Description of Work
SFD/ Construct a 13 x 17 screened in porch on rear of home.

B:25001420 (13' x 17' porch)
 Approved 5/19/25 - H.O.

From: Oswald Jr, Woodin
Sent: Monday, May 19, 2025 9:24 AM
To: 'terry@dormanhomeremodeling.com'
Cc: 'CJ@DORMANHOMEREMODELING.COM'
Subject: B25001420_1660 Shaffersville Road_Site Plan
Attachments: WS_Shaffersville_1660_BuildingPermit.pdf

Proposed Screened-In Covered Deck Addition
to the
SCHRIDER RESIDENCE
1660 Shaffersville Road, Mt. Airy, MD. 21771

LOCATION DRAWING

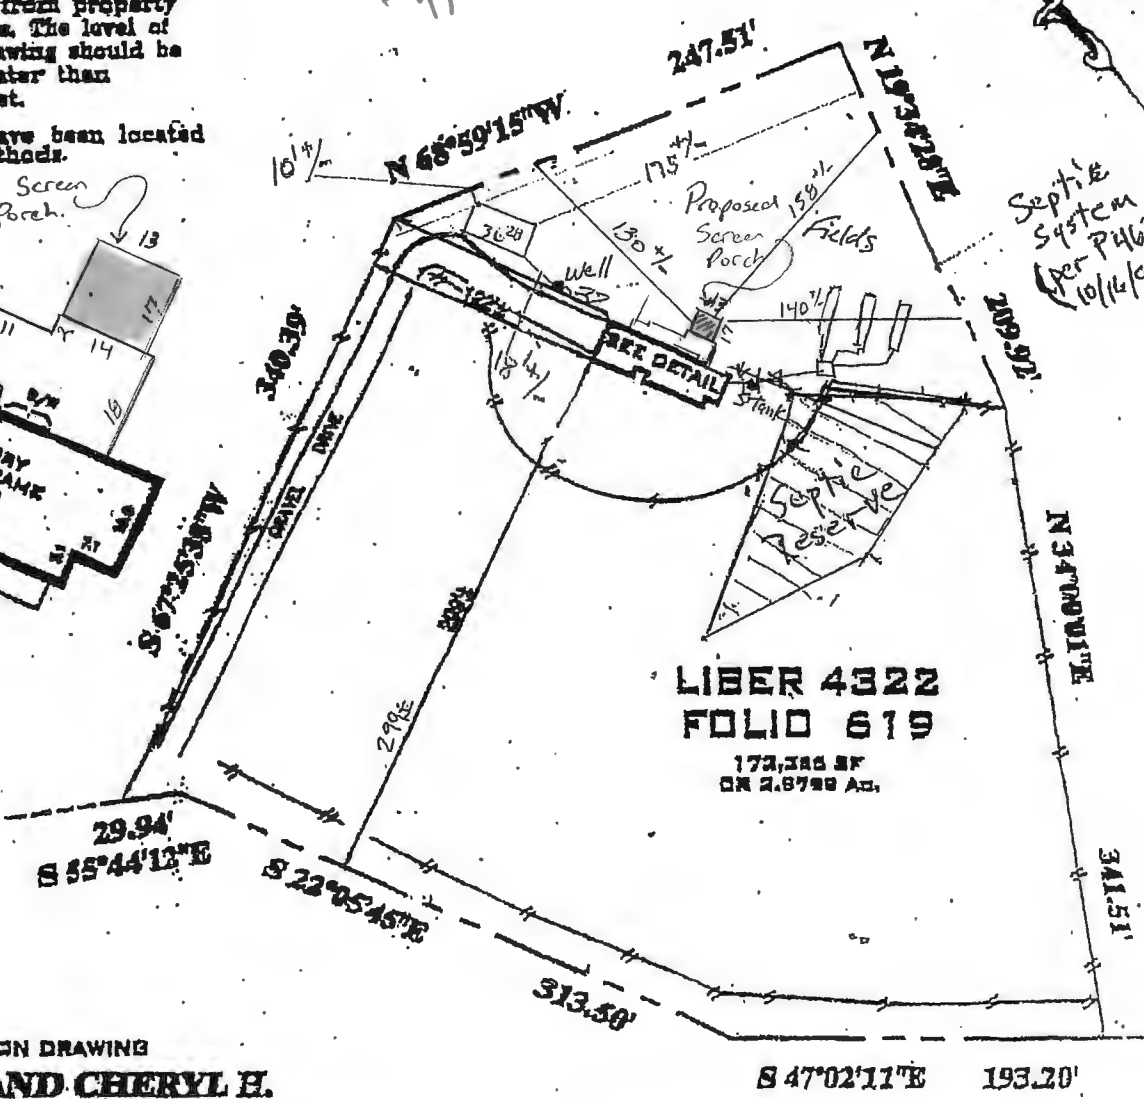
The site plan for BP# B25001420 does not appear to include the building addition in 2012 (Please see attachment). Please revise site plan to include the correct house foot print. Please do not include any previous stamp approvals on the revised site plan. Once the site plan has been submitted/uploaded to DILP, please let me know.
